**Additional Comments, Whistling Ridge DEIS
Keith Brown, Ph.D. and Teresa Robbins**

**Energy Facility Site Evaluation Council
905 Plum Street SE
P.O. Box 43172
Olympia, WA 98504-3172**

August 20, 2010

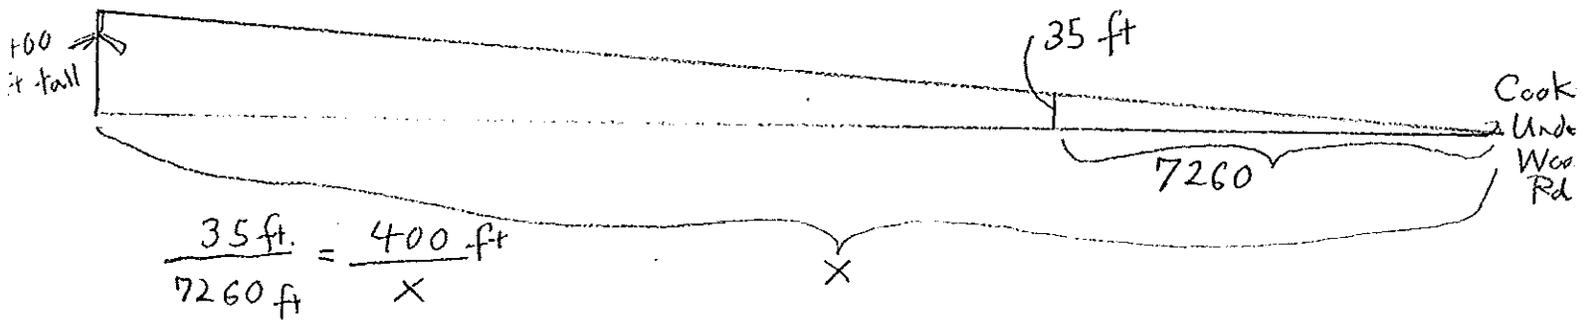
How far away from the scenic area boundary would a 400-ft. tower have to be, to be the visual equivalent on the boundary of a 35 ft tall structure (typical house height) as seen from the Cook-Underwood Rd.?

$$\frac{35 \text{ ft.}}{7260 \text{ ft}} = \frac{400 \text{ ft}}{x}$$

Photo Locations - Key Viewing Areas

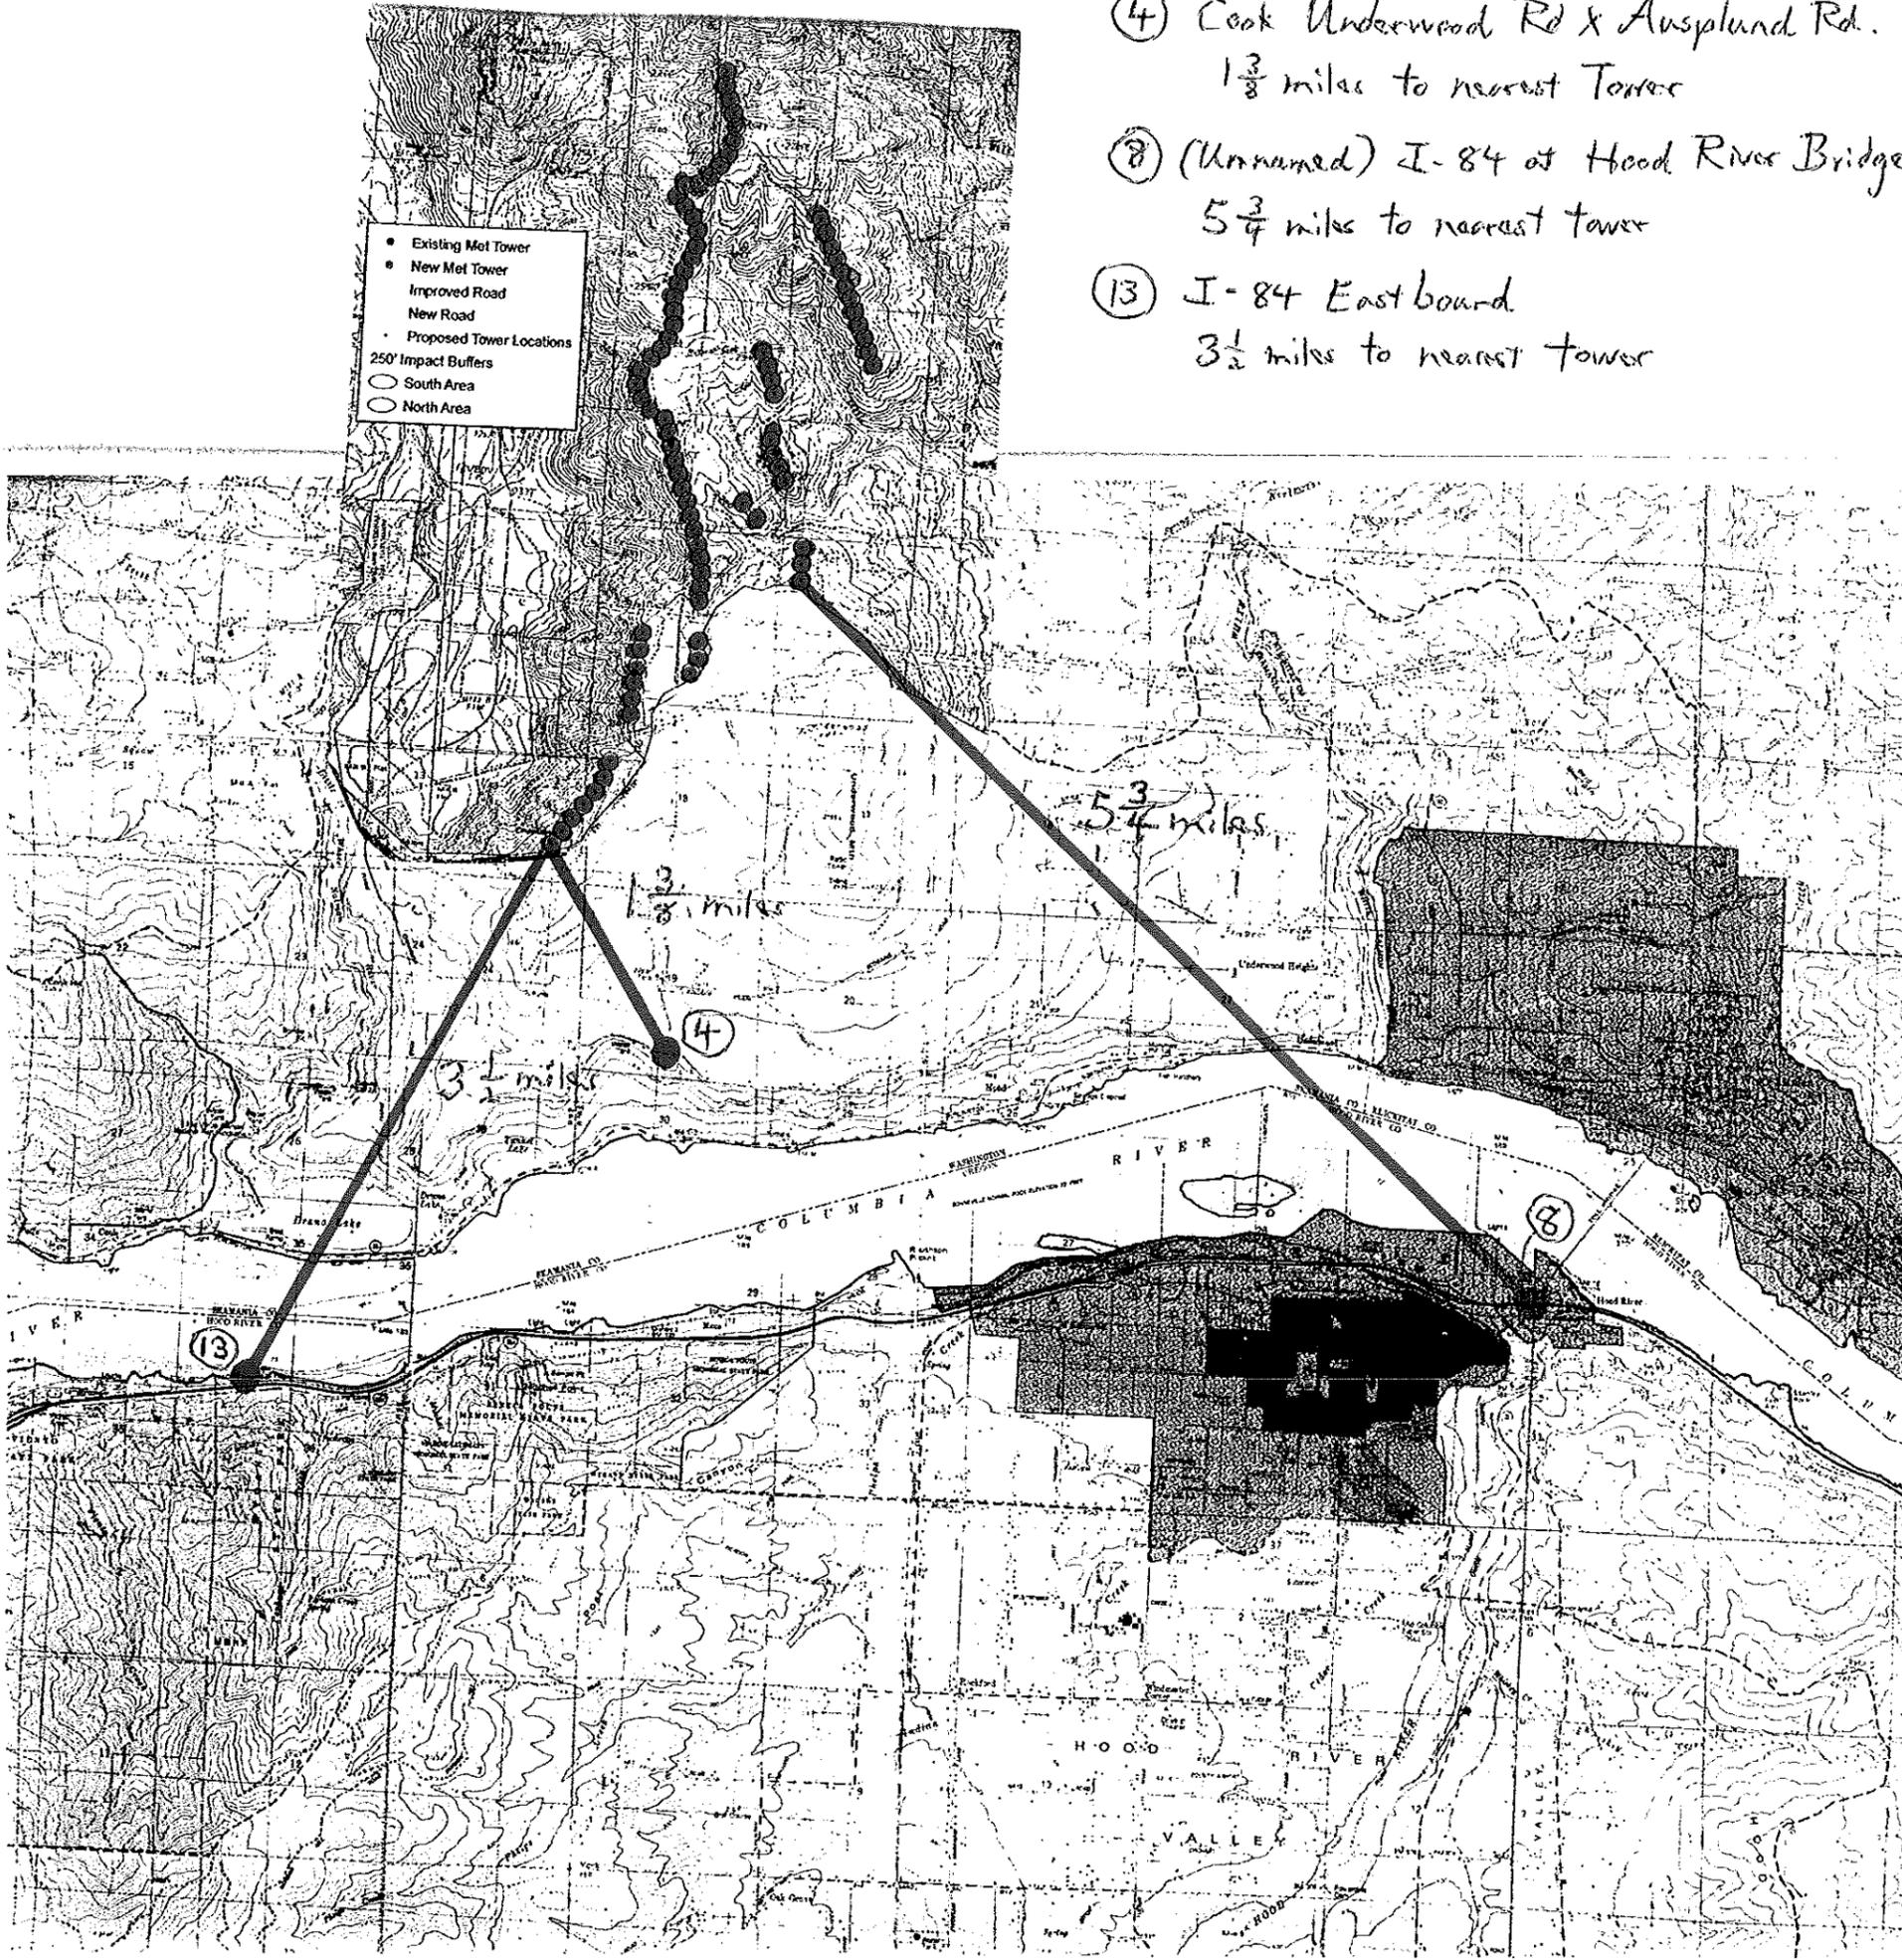
- ④ Cook Underwood Rd x Ausplund Rd.
1 $\frac{3}{8}$ miles to nearest Tower
- ⑧ (Unnamed) I-84 at Hood River Bridge
5 $\frac{3}{4}$ miles to nearest tower
- ⑬ I-84 Eastbound
3 $\frac{1}{2}$ miles to nearest tower
